UNITED STATES OF AMERICA
CIVIL AERONAUTICS BOARD
WASHINGTON, D. C.

Civil Air Regulations Amendment 4b-6
Effective: March 5, 1952
Adopted: January 28, 1952

AIRPLANE AIRWORTHINESS - TRANSPORT CATEGORIES

FIGURE 4b-15a PICTORIAL DEFINITION OF ANGLES, DIMENSIONS, AND DIRECTIONS ON A SEAPLANE.

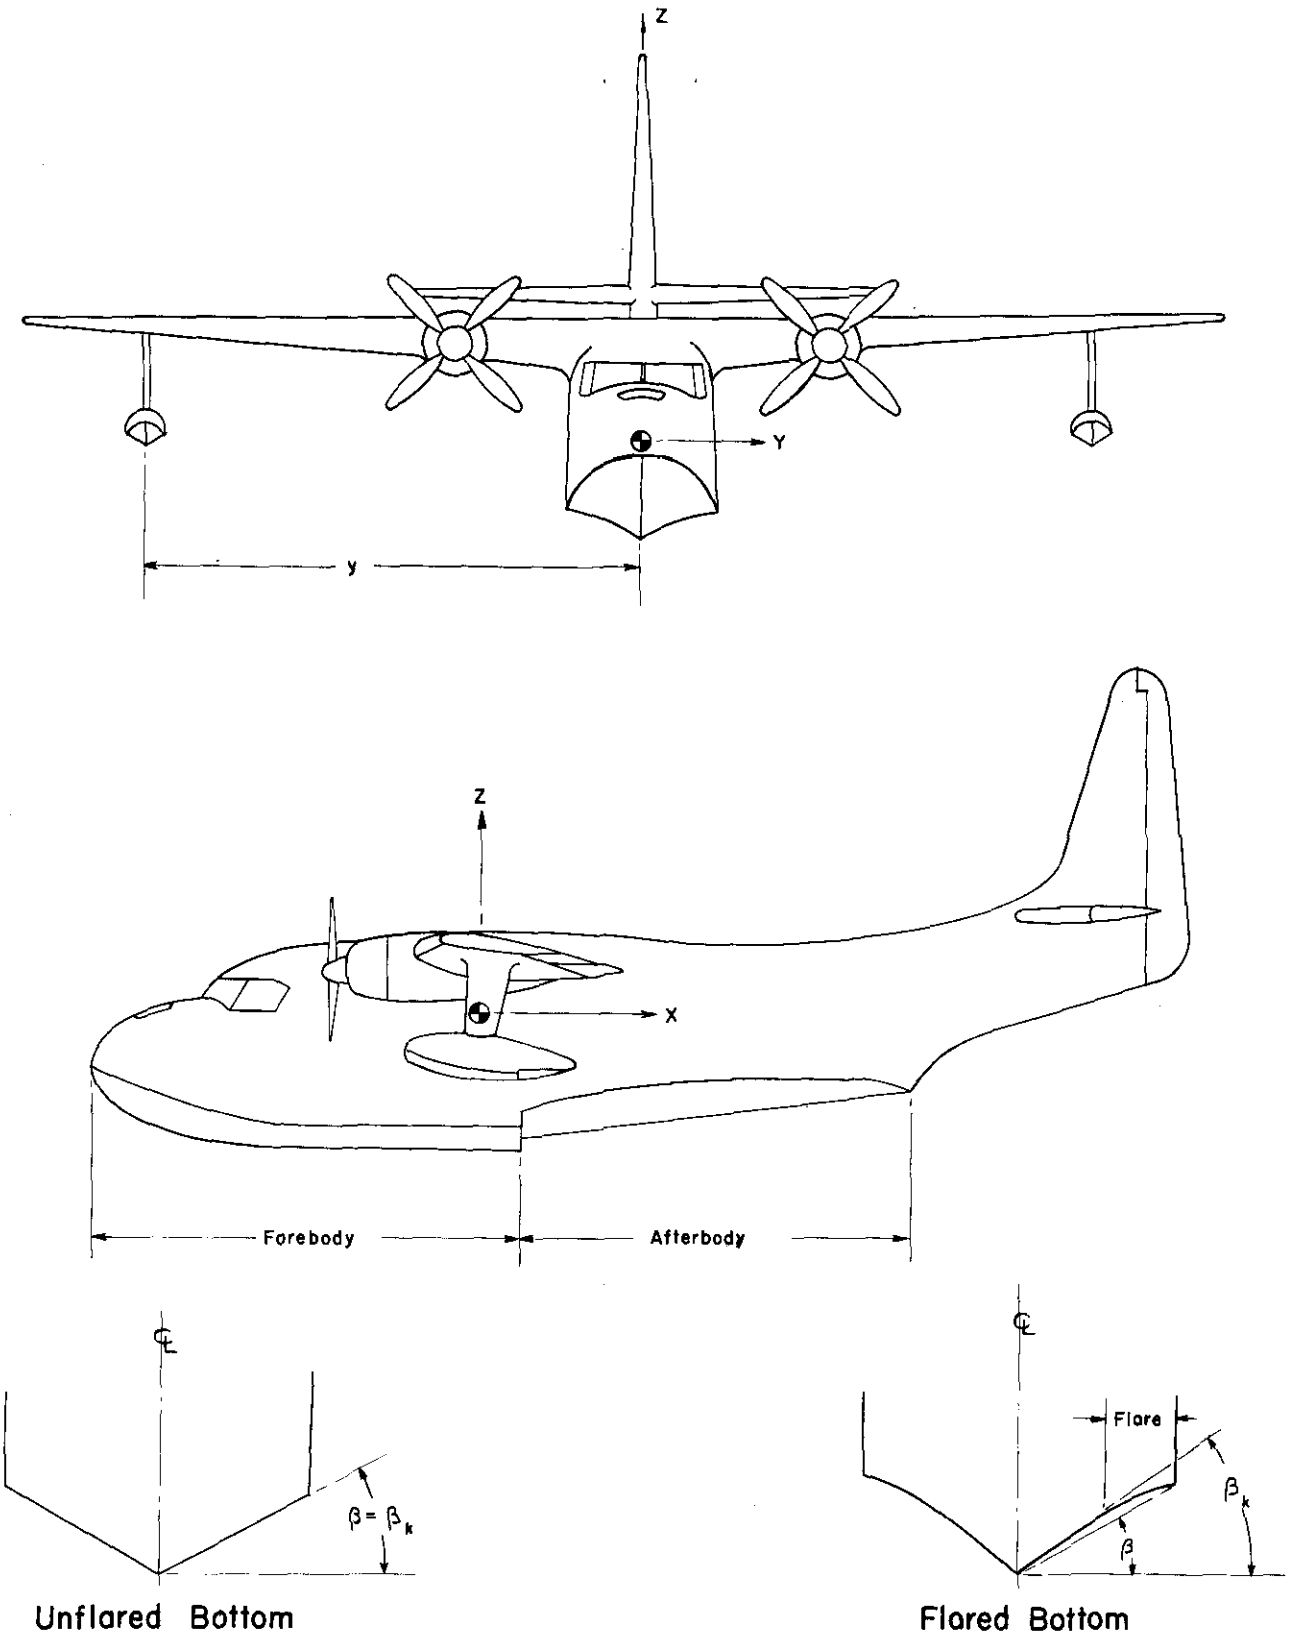
25. By rescinding Figure 4b-15 and inserting in lieu thereof new Figures 4b-15a, 4b-15b, and 4b-15c and by amending §§ 4b.250 through 4b.257 to read as follows:

β = angle of dead rise at the longitudinal station at which the load factor is being determined (see Figure 4b-15a);

β_k = angle of dead rise at keel (see Figure 4b-15a).

FIGURE 4b-15b HULL STATION WEIGHING FACTOR

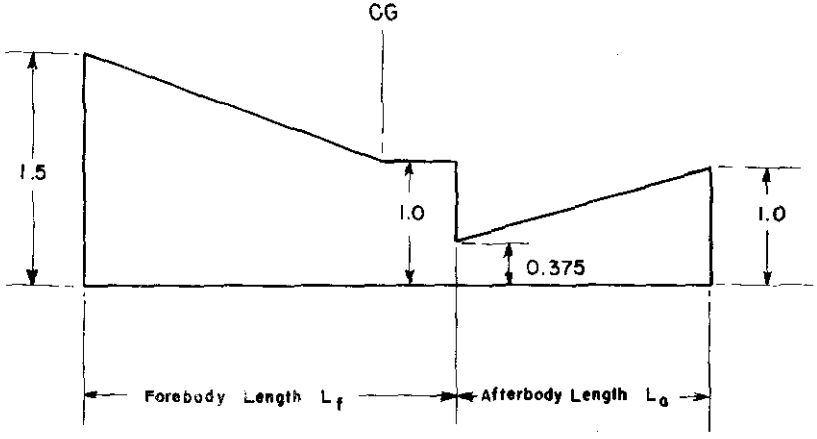
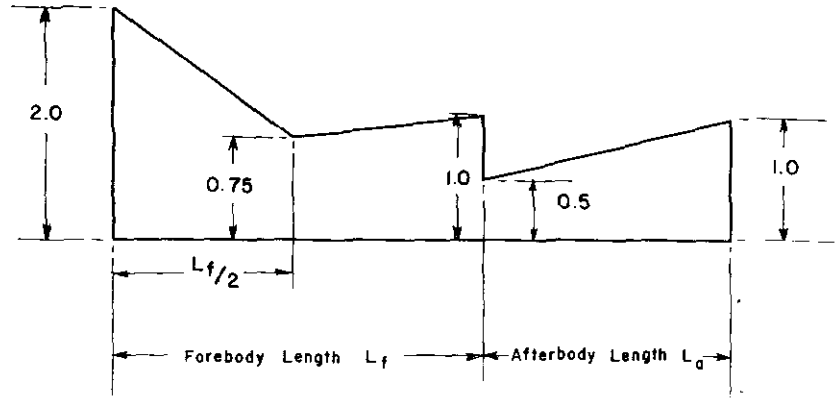
K_1 = empirical hull station weighing factor. (See Figure 4b-15b.) For a twin float seaplane, in recognition of the effect of flexibility of the attachment of the floats to the seaplane, it shall be acceptable to reduce the factor K_1 at the bow and stern to 0.8 of the value shown in Figure 4b-15b. This reduction shall not apply to the float design but only to the design of the carry-through and seaplane structure;

K_2 = hull station weighing factor (see Figure 4b-15b);

38871 **FIGURE 4b-15c TRANSVERSE PRESSURE DISTRIBUTIONS**

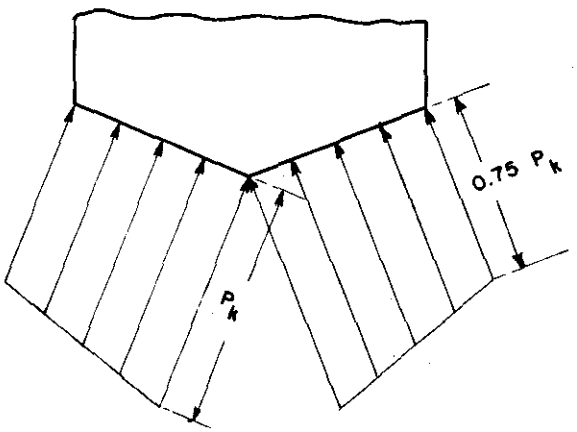
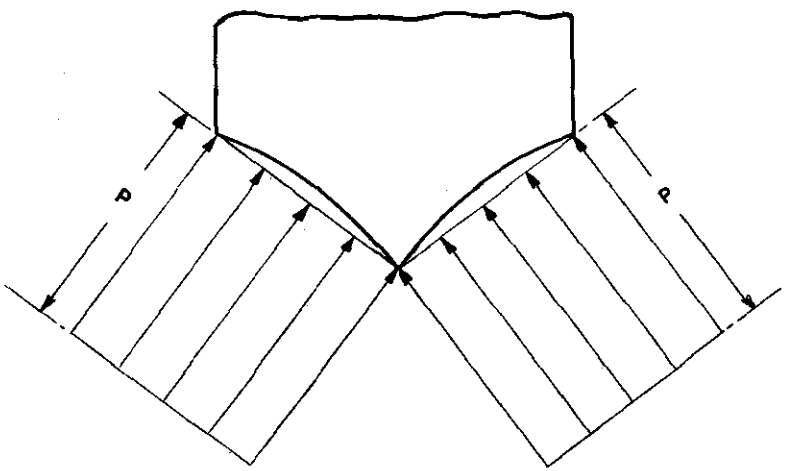
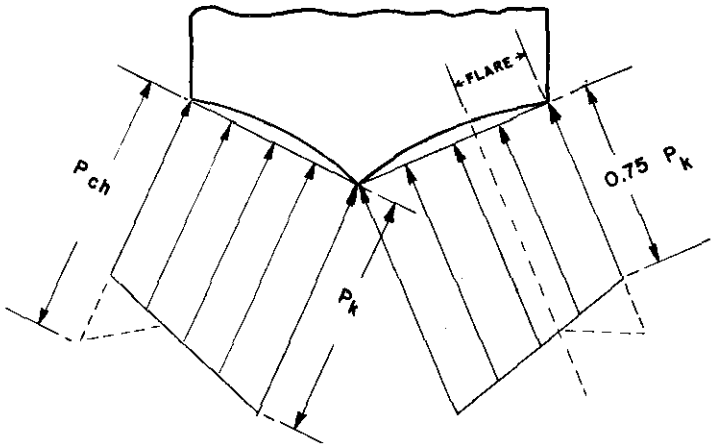
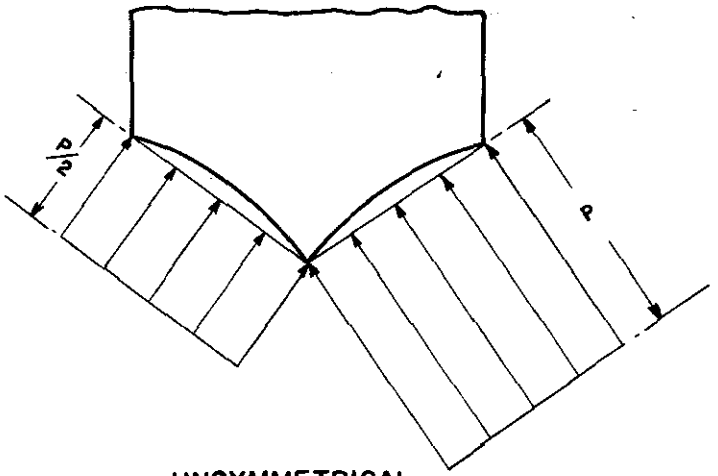
The pressure at the chine shall be 0.75 P_k, and the pressures between the keel and chine shall vary linearly. (See Figure 4b-15c.)

The pressure at the beginning of the flare shall be the same as for an unflared bottom, and the pressure between the chine and the beginning of the flare shall vary linearly. (See Figure 4b-15c.)

(2) Unsymmetrical. The unsymmetrical pressure distribution shall consist of the pressures prescribed in subparagraph (1) of this paragraph on one side of the hull or main float center line and one-half of that pressure on the other side of the hull or main float center line. (See Figure 4b-15c.)
